196-200 Quay Street (MSocial Hotel) – Downtown West Development FTAA Review – Structural Memorandum

Structus has been engaged by Millennium & Copthorne Hotels New Zealand Limited (MCK) to provide a structural engineering review of the FTAA submission on the building at 196-200 Quay Street due to the proposed Downtown West development.

APPENDIX A: Holmes Consulting “Downtown Carpark Site Development – Response To M-Social Structural Consultant Structus Items” Memorandum Dated 28 April 2026

Downtown Carpark Site Development – Response to M-Social structural consultant Structus items

Figure 5 – Extent of MSocial building shallow foundations and probable slab on grade as outlined in green (ref Structure Design drawing S2-01(5) dated 23 April 2015).

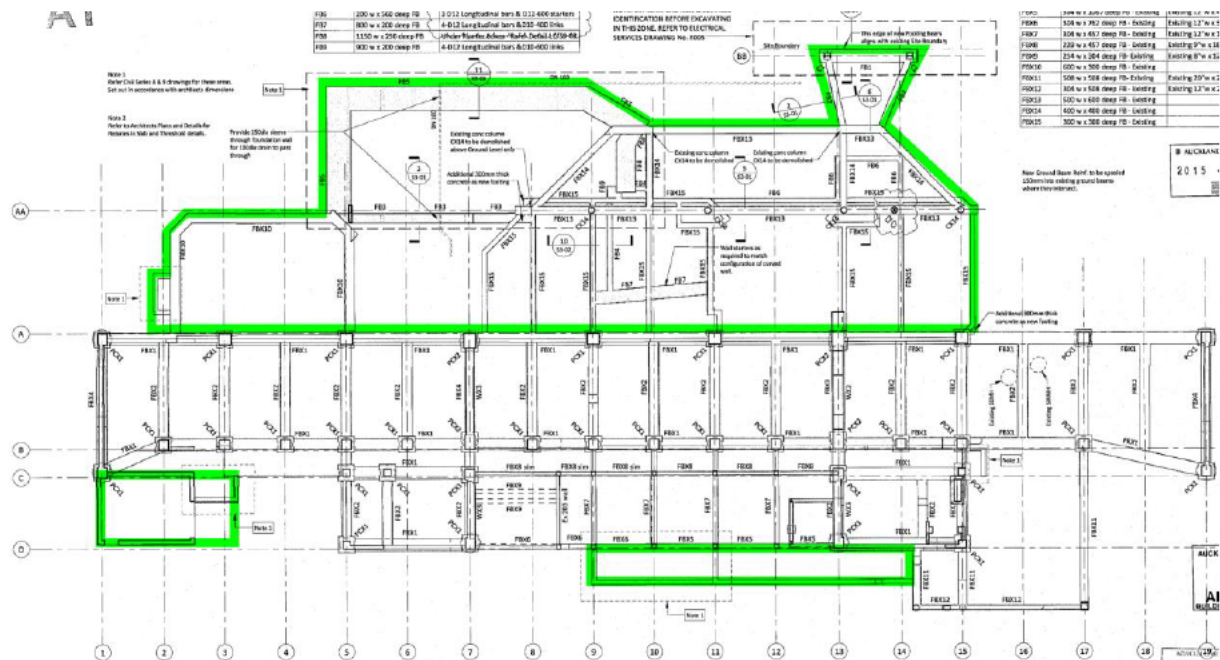
30. Refer item 27 above.
32. The MSocial building is supported on shallow foundations as shown in Figure 5. Additionally, at least a large portion of the ground floor slab is supported on grade. Therefore, these structures are more susceptible to settlement than suspended structure supported on pile foundations. Structus proposes a resource consent condition requiring that settlements due to demolition, construction sequencing and diaphragm retaining wall deflection are limited to those causing no noticeable damage to these shallow founded brittle structures.

TOP DOWN RETAINING NORTH WALL SCHEMATIC SECTION

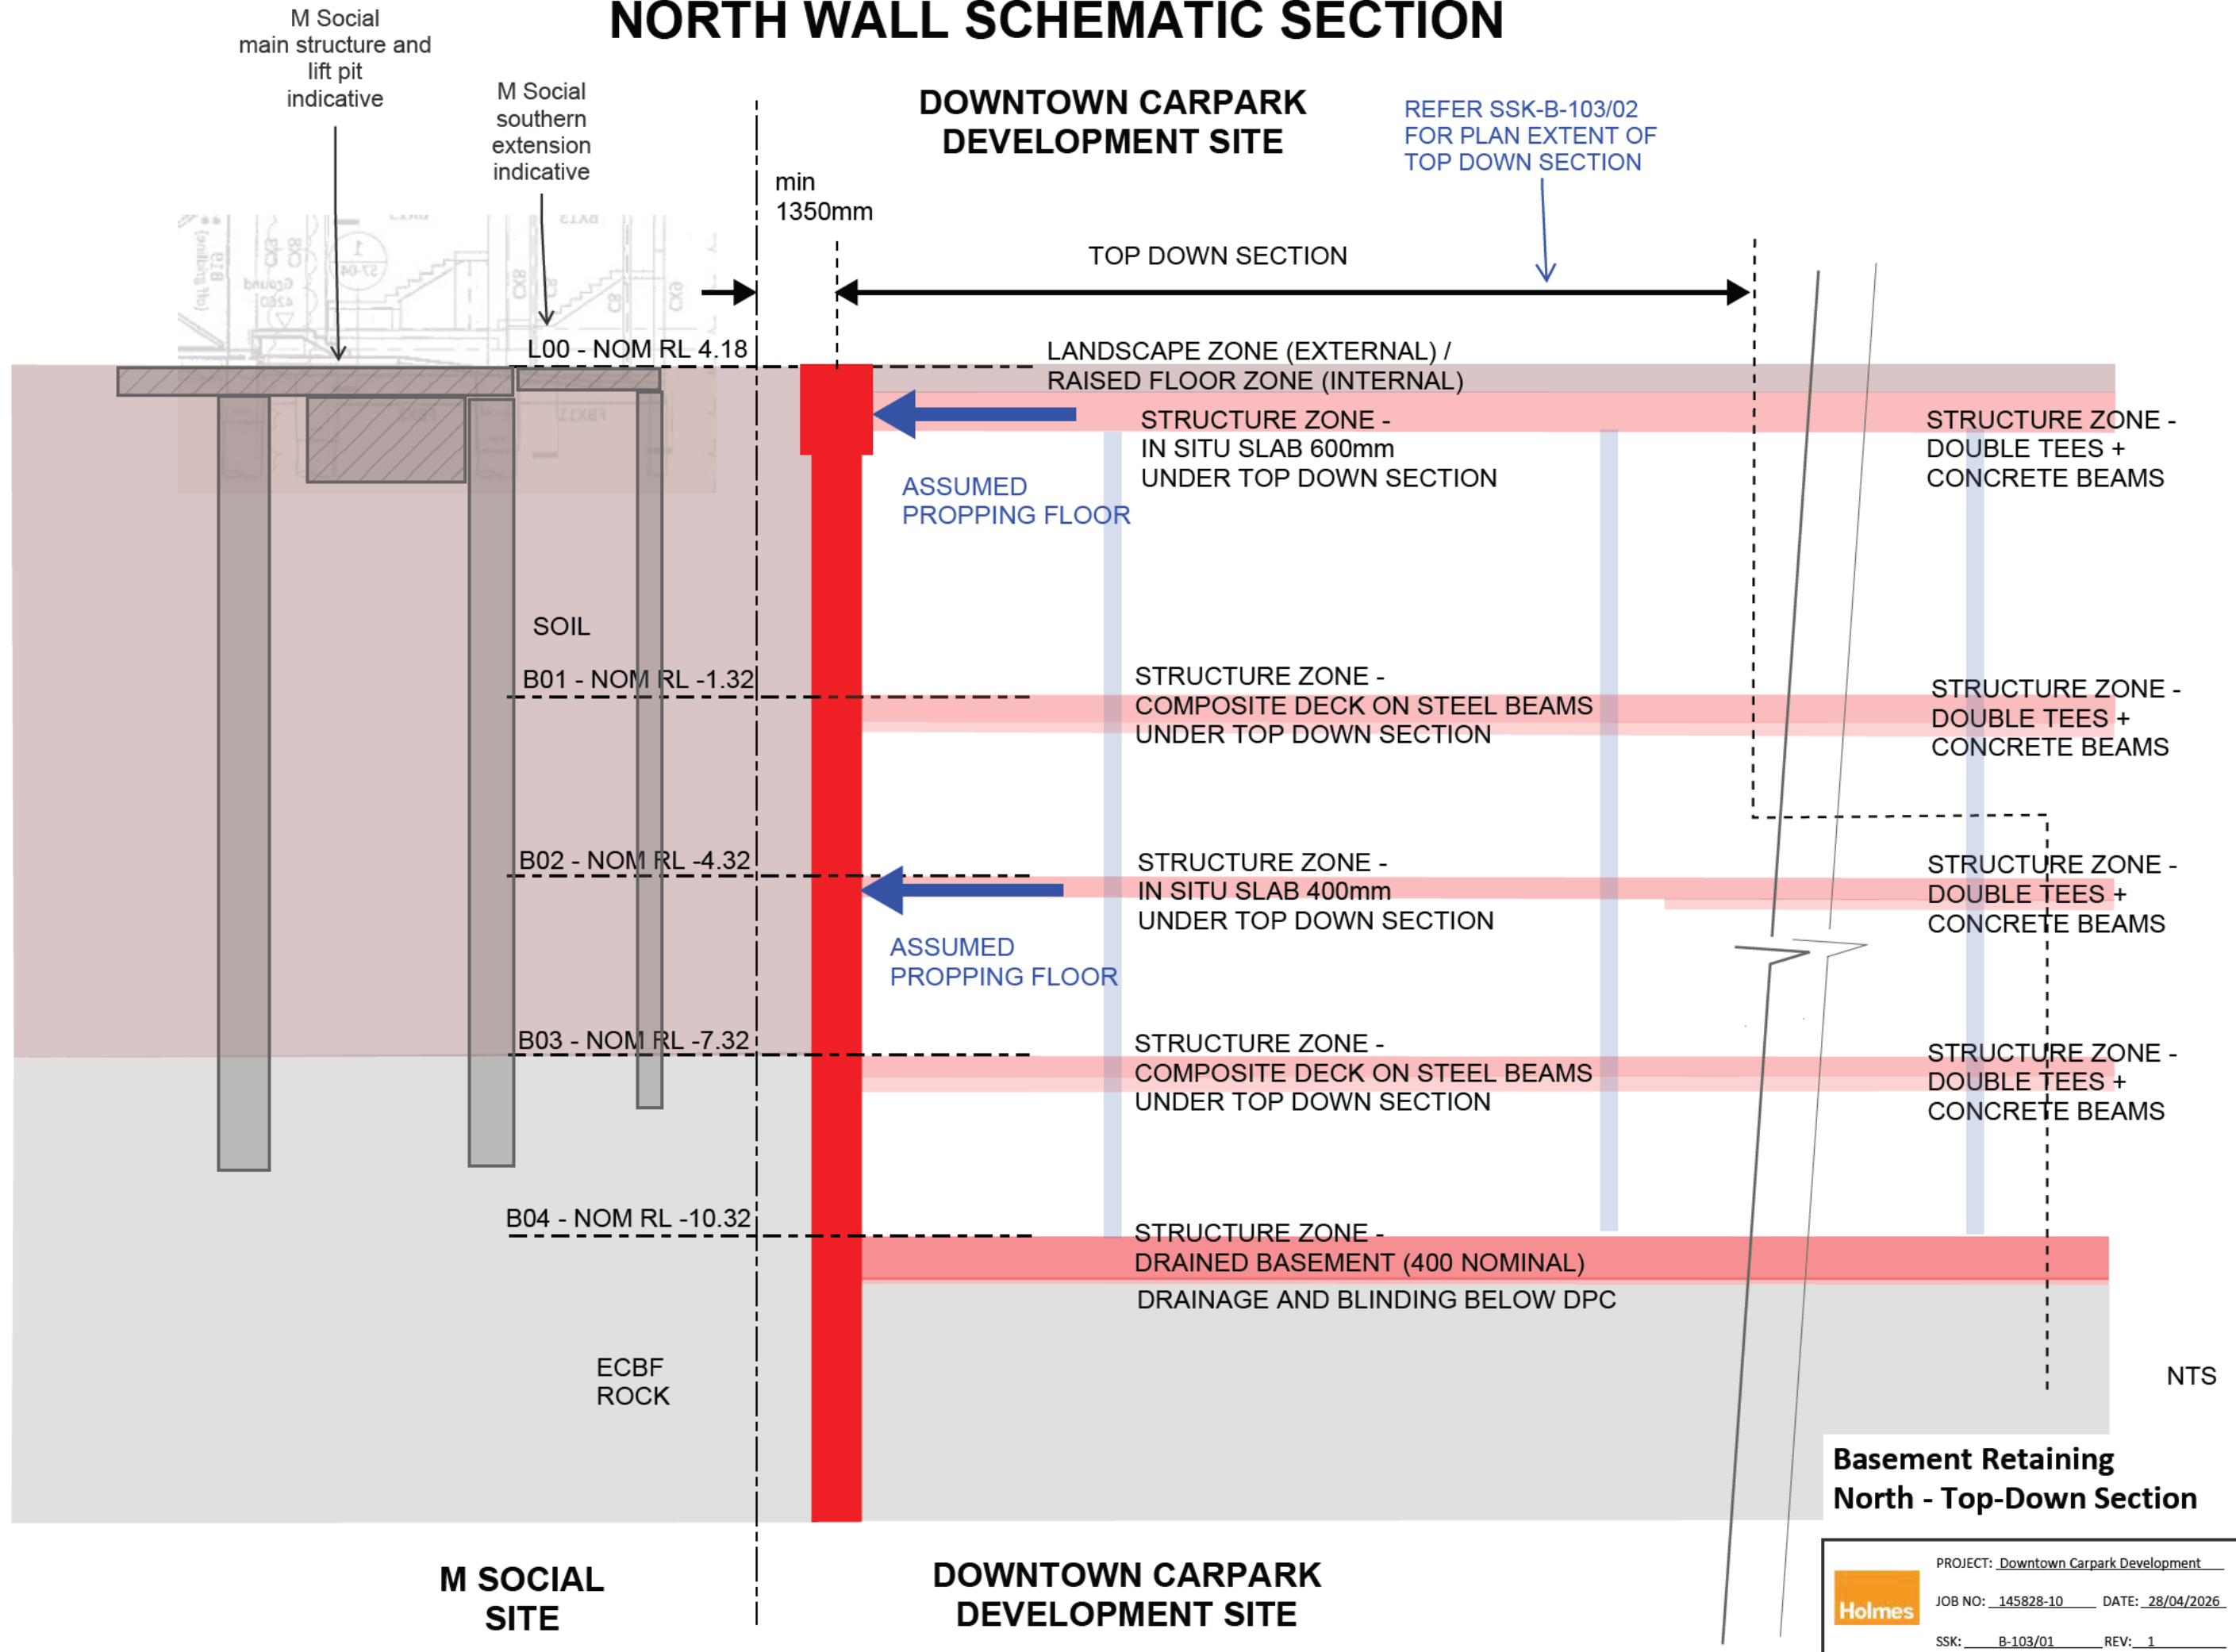
16. Structus accepts that the proposed top-down structural scheme included in the Holmes Report is commensurate with the Tonkin + Taylor Wallap analysis for extent on plan and thickness of propping slabs. It is assumed that these are solid slabs and openings in these propping slabs will be cut out after the remainder of the basement structures are built, and that the propping slabs are designed to consider these openings in the permanent condition, without reducing the stiffness of the propping on the retaining wall from the temporary to the permanent condition. Structus proposes a resource consent condition requiring confirmation through detailed structural engineering design information that the Structus comments are addressed.

BASE SHEAR TAKE OUT SCHEMATIC

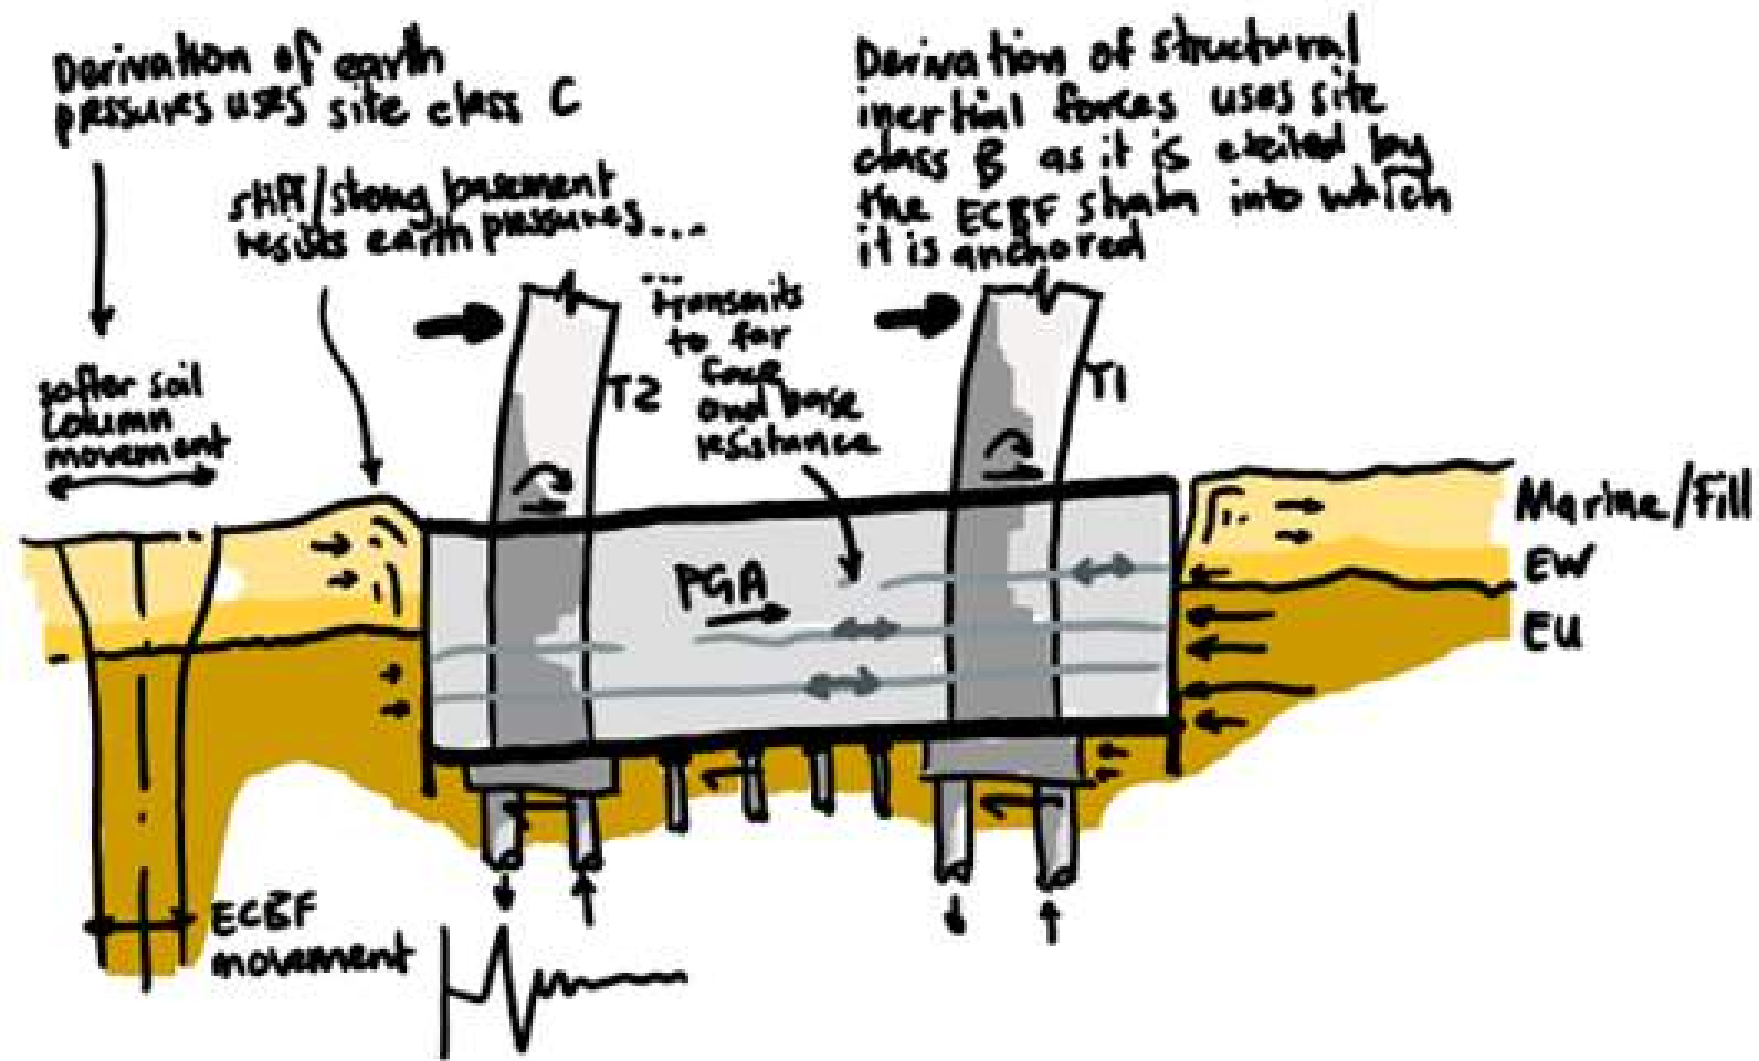
- The Applicant should be required to provide confirmation that base shear of the proposed building will not cause northern diaphragm wall deflections greater than those advised in the static condition and that base shear effects of the MSocial building are considered on the Downtown West development basement structures.

Holmes have undertaken designs for the lateral loading including the basement impacts of this design. A high-level diagram is provided to show the philosophy for this, as requested, refer to appendix 4 in the attached material.
